9. **Official Plan Amendment and Zoning By-law Amendment - 278 O'Connor Street, 280 O'Connor Street and 347 Gilmour Street**

File Number: ACS2020-PIE-PS-0083

**SUBJECT: Official Plan Amendment and Zoning By-law Amendment - 278
O'Connor Street, 280 O'Connor Street and 347 Gilmour Street**

Document 5 – Building Cross-section

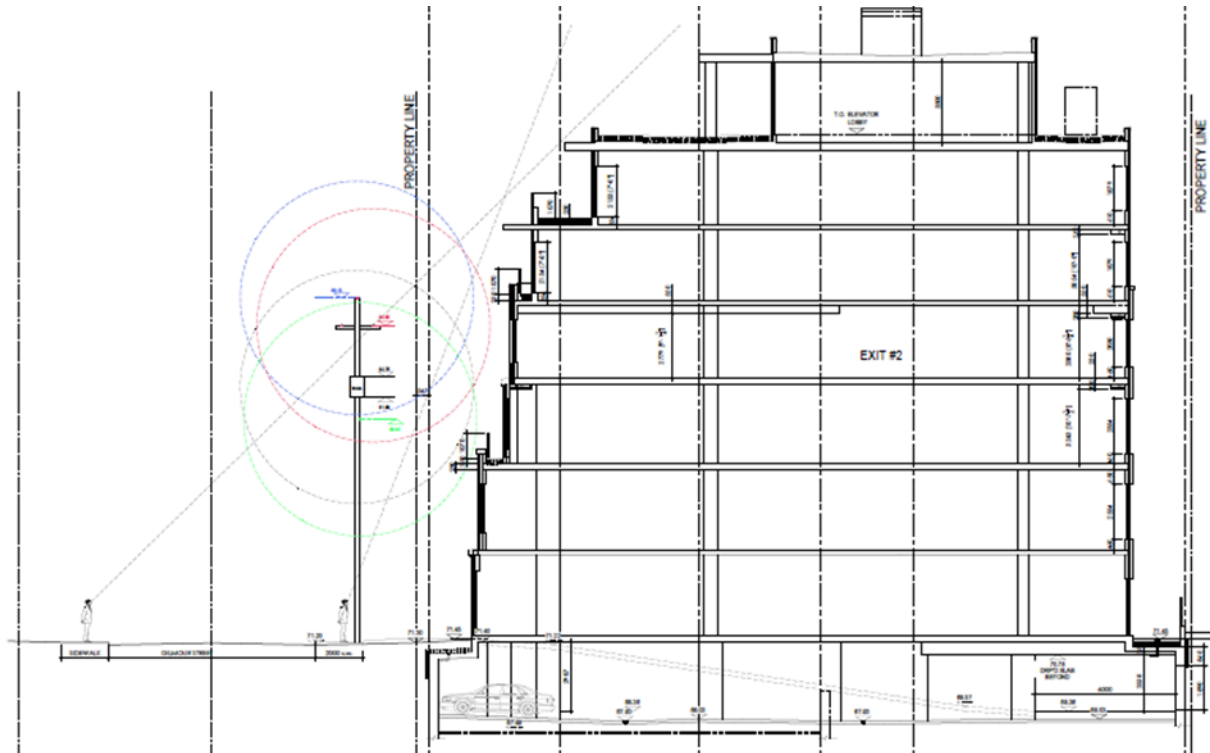
Local residents and community association representatives expressed their concerns that allowing increased building height will create a precedent for future development throughout the area.

The proposed built form is not in keeping with the character of the existing heritage houses across Gilmour Street.

The proposed design is sensitive to its context as it provides several setbacks at different levels, which setbacks are more significant for the additional two storeys.

The incremental increases in building height will ensure proper height transition from a north-south perspective and an east-west perspective. The use of lighter materials and glazing on the upper storeys, and generous articulation will also contribute to minimize the perceived mass.

Brick will be used for the first four(4) storeys and generous articulation will also be provided along Gilmour Street to respect the scale and rhythm of the streetscape.

Document 6 – Site Plan

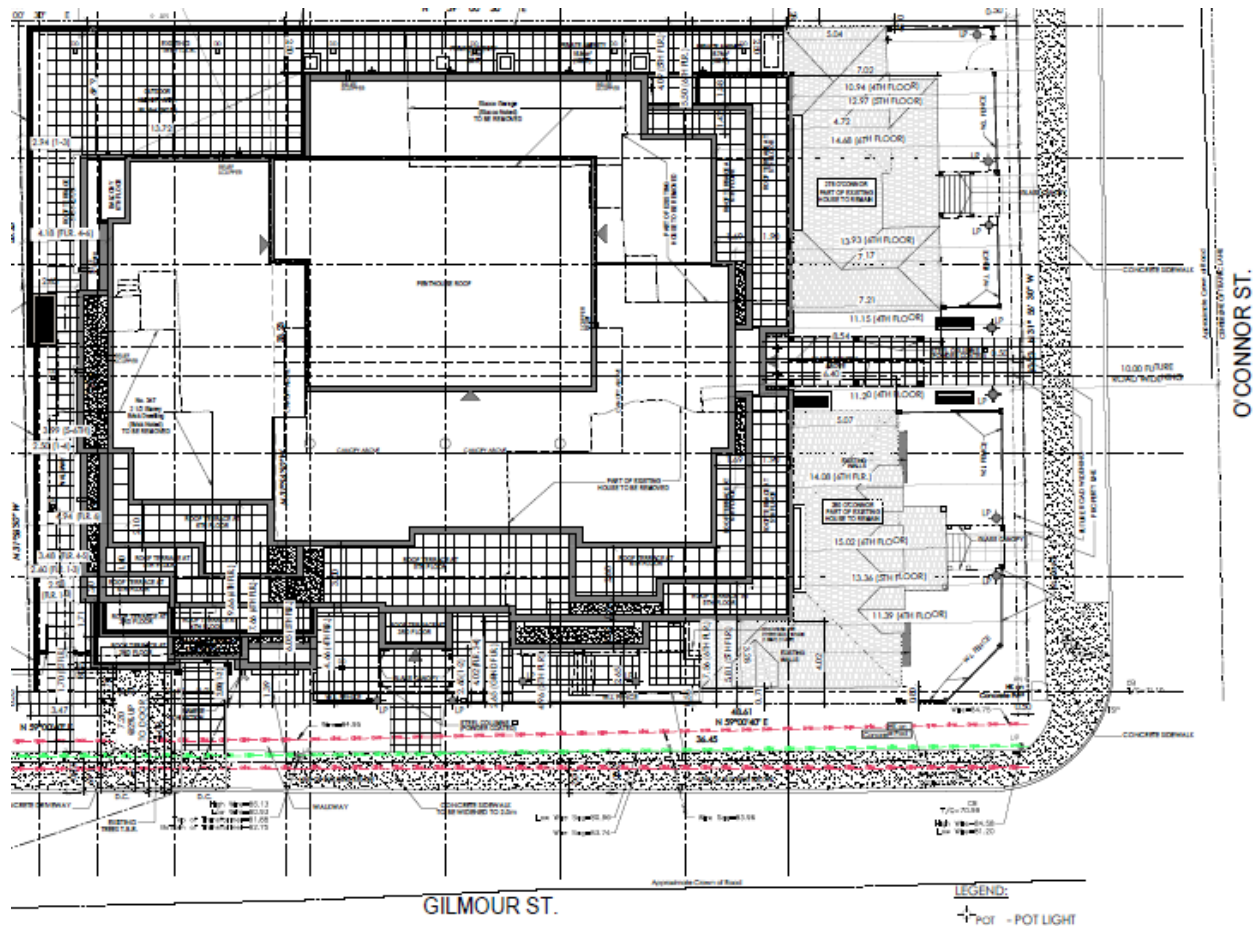
The proposed development should maintain as much greenery as possible.

The mature trees along O'Connor Street will be preserved.
